**To:**  
Michael Liberati, Corteva**CC:**  
Joshua Collins, AECOM  
Kevin Suter, AECOM  
Matt Pritchett, Summit**Project name:**  
South River AOC 4**From:**  
Cameron Dixon, PE, AECOM**Date:**  
September 1, 2020

**Subject:** Shiloh Baptist Church Bank Erosion

Photo 2 - Bank Erosion at Top of Bank

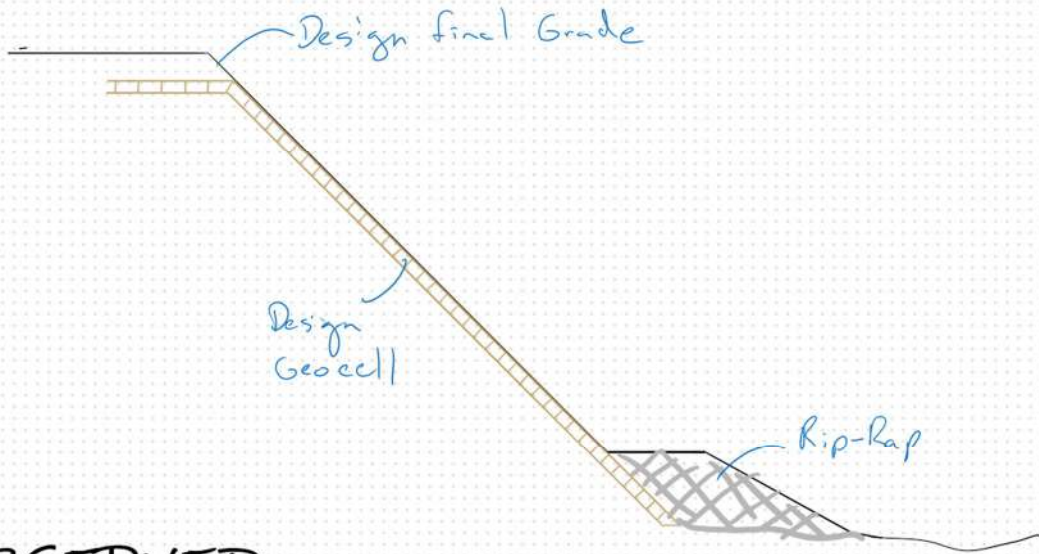
On August 26, 2020, an inspection of the bank stabilization measures at the Shiloh Baptist Church identified a section of bank where significant erosion of the bank was observed with sloughing of the surface soils down the bank into the rip-rap toe exposing the geocell below. This erosion extended along approximately 140 linear feet from relative river mile (RRM) 0.60 to 0.63, where excavation was conducted during the remedial activities. The erosion covered approximately 75% of the area from 2' feet below the top of bank to the top of the rip-rap toe (Photos 1-3).

In order to address this erosion and prevent future sloughing of materials, the existing soil above the geocell should be removed from the riprap toe to the top of the bank. Then a thin layer of planting substrate should be used to fill in any voids in the geocell pockets and cover the geocell, with no more than 1"-2" of material placed over the geocell, to match the Typical Primary B Restoration Cross Section on Sheet X-102 of the Shiloh Baptist Church Design Drawings and the restoration details on D-201 and D-202. The planting substrate should be seeded with an erosion control mix and covered with an erosion control blanket that is properly anchored at the top of the bank per the details in the construction drawings. The repaired area should be watered as needed between storms through the end of the fall growth season. In the spring, the area should be hydroseeded with the design bank mixture and shrubs re-planted as needed. Watering should be maintained through the summer as needed to fully establish vegetated growth, per specification 32 90 00 Planting and Habitat Restoration.

Photo 3 - Sloughed Material on Stone Toe

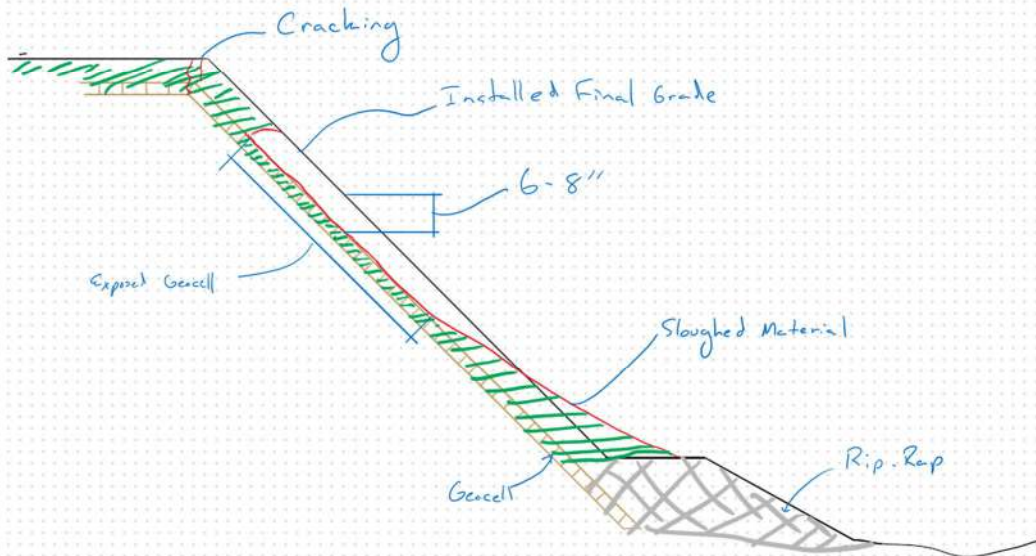
In the eroded areas where there was undisturbed material there was approximately 6-8" of soil placed above the face of the geocell (Photo 4). This excess soil slid along the face of the geocell until it formed a buttress at the bottom of the slope against the stone toe, likely resulting from storm events that eroded the buttressing soils at the bottom of the bank which led to the material sliding down the face of the bank. Areas along the top of the slope where erosion occurred exhibited cracking from the loss of structural support on the face of the bank. The cracking appears to be a trailing indicator; rather than appearing before the erosion occurs, it forms after the bank materials slid down the face of the bank.
